# Gatwick Airport Northern Runway Project

Statement of Common Ground Between Gatwick Airport Limited and Surrey County Council – Tracked Version

Application Document Ref: 10.1.8

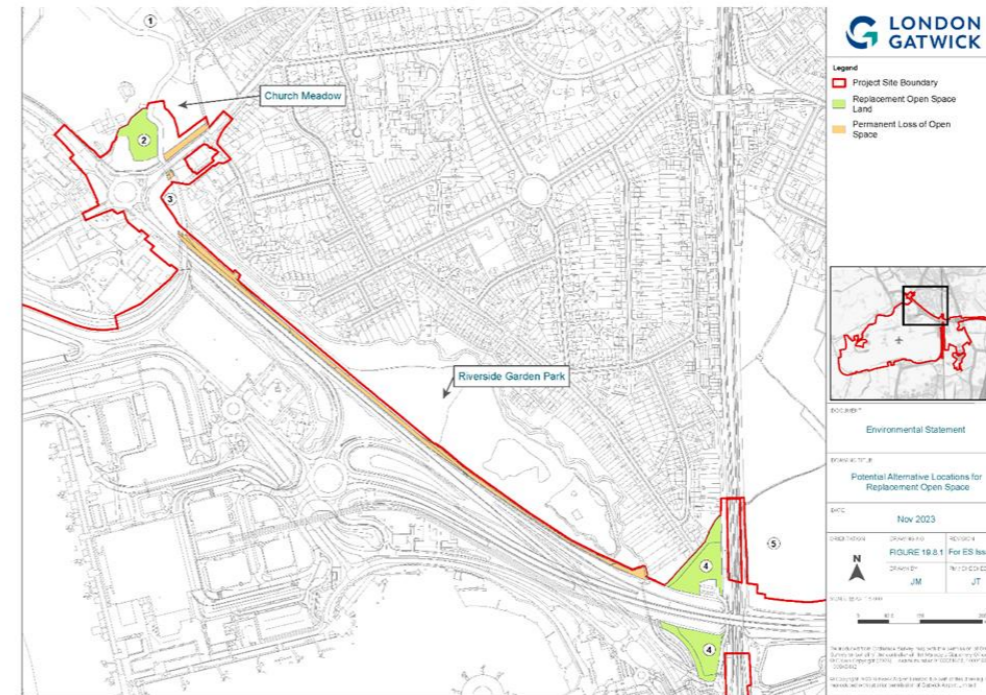
A range of potential options for suitable replacement open space were considered and their locations are shown on the figure below (overlaid onto Figure 19.8.1 of the ES [APP-058]).

All are in relatively close proximity to the open space to be lost, in accordance with the requirements of Reigate and Banstead Local Plan Policy OSR 1 for the establishment of Urban Open Space under.
